SERVICE BULLETIN

ENGINE - NO. 4 BEARING COMPARTMENT - PROVIDE A NEW NO. 4 BEARING SEAL ASSEMBLY WITH NUTS SILVER PLATED ON THE THREADS ONLY - CATEGORY CODE 8 - MOD.ENG-72-0163

V2500-ENG-72-0163

Location of the No. 4 Bearing Seal Support
Fig.1

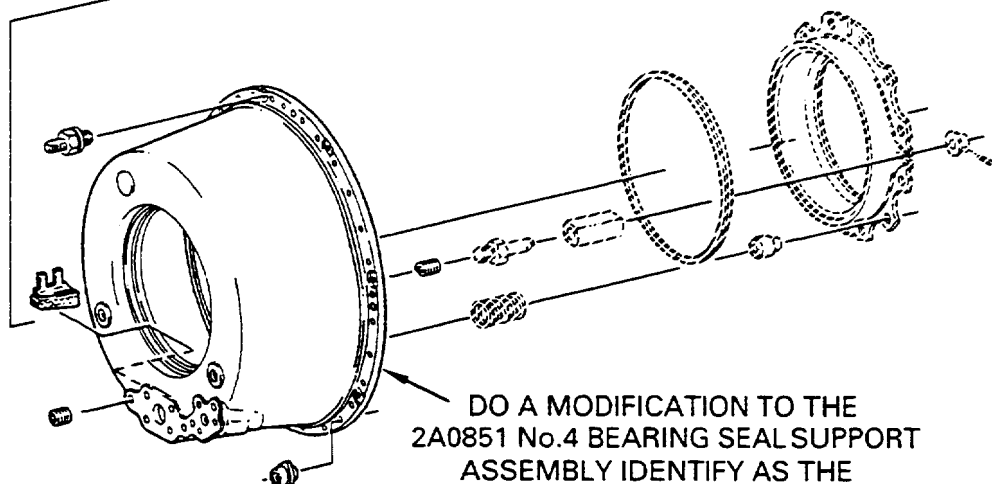
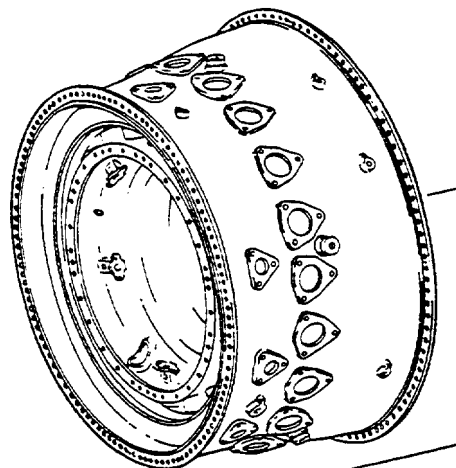
- (1) For V2500-A5 Engines proceed as follows:
- (a) When you assemble the No. 4 Bearing Front Seal Assembly, install the 2A2833 No. 4 Bearing Seal Support Assembly (1 off) by the procedure given in Reference (3), Chapter/Section 72-42-33, Assembly. Refer to Figure 1.

DO A MODIFICATION TO THE
2A0851 No.4 BEARING SEAL SUPPORT
ASSEMBLY IDENTIFY AS THE
2A2833 No.4 BEARING SEAL SUPPORT
ASSEMBLY (1 off) AND INSTALL

Modification of the No. 4 Bearing Seal Support
Fig.2

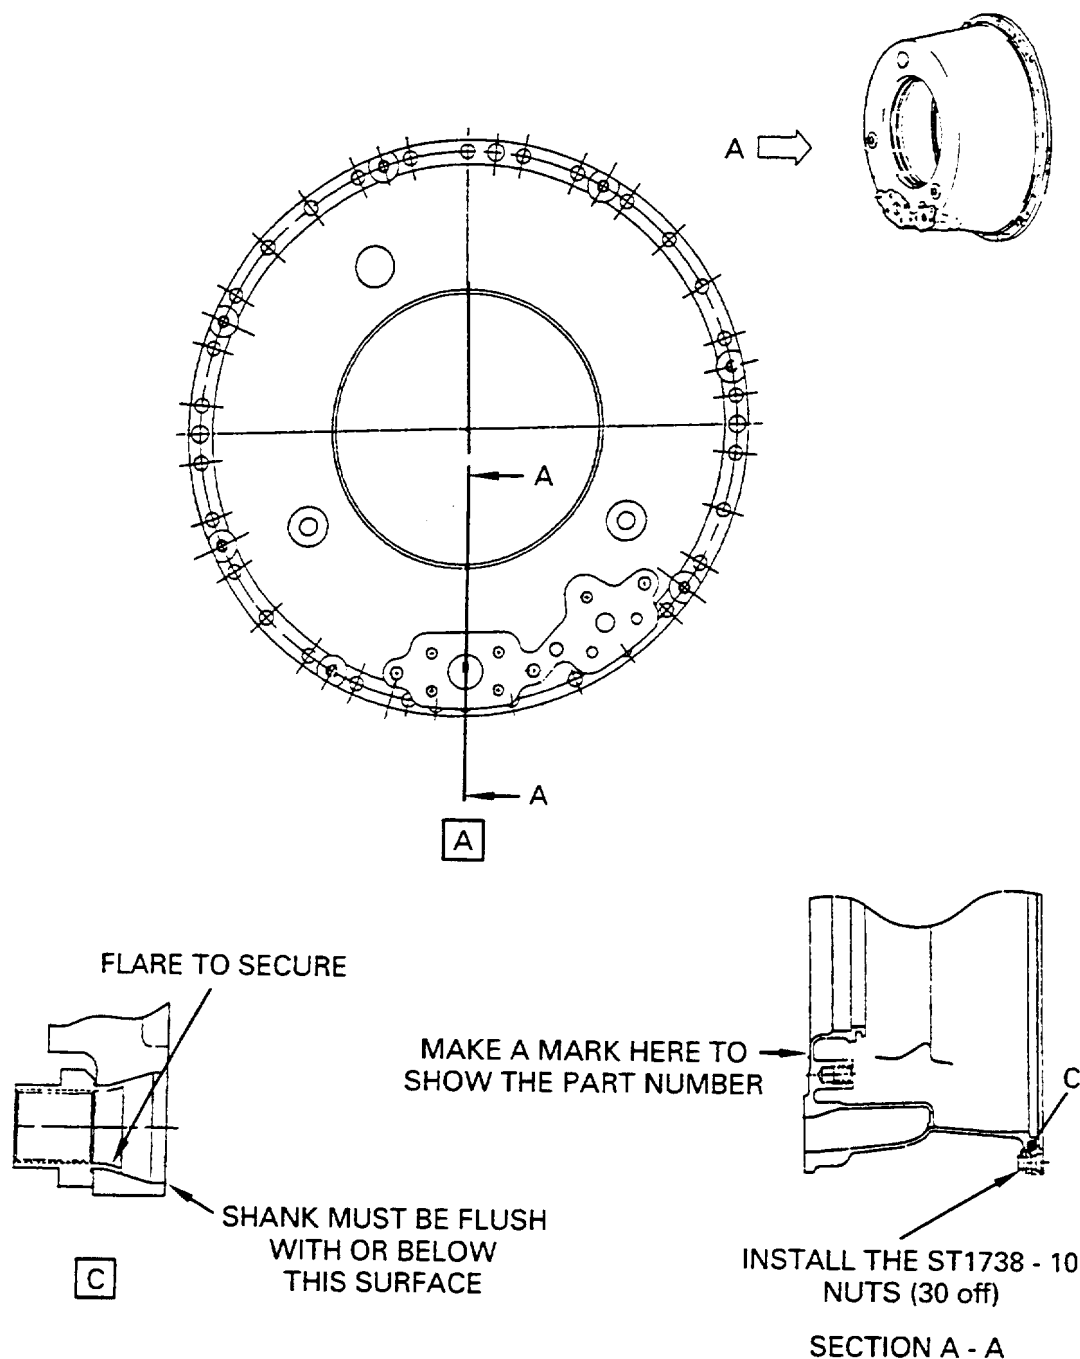
Procedure	Supplementary Information				
(a) Remove the self locking clinch nuts from the No. 4 Bearing Support Assembly as follows: 1 Drill out the nuts with the applicable size drill.	Refer to Figures 1 and 2.				
(b) Install the new self locking clinch nuts from the ST1738-10 Nut Option (30 off) by Figure 2 and as follows: 1 Put the nut in position on the front face of the rear flange. 2 Flare the nut as shown in Figure 2. 3 Do the procedures again until nuts are installed at all locations.	Refer to Figures 1 and 2.				
(c) Mark the new part number adjacent to the old part number. Use the vibration peen method.	<table><tr><th>Old Part Number</th><th>New Part Number</th></tr><tr><td>2A0851</td><td>2A2833</td></tr></table> Refer to Figure 2 requirements. Refer to the approved procedure Reference (2), Control No./TASK No. 70-09-00-400-501.	Old Part Number	New Part Number	2A0851	2A2833
Old Part Number	New Part Number				
2A0851	2A2833
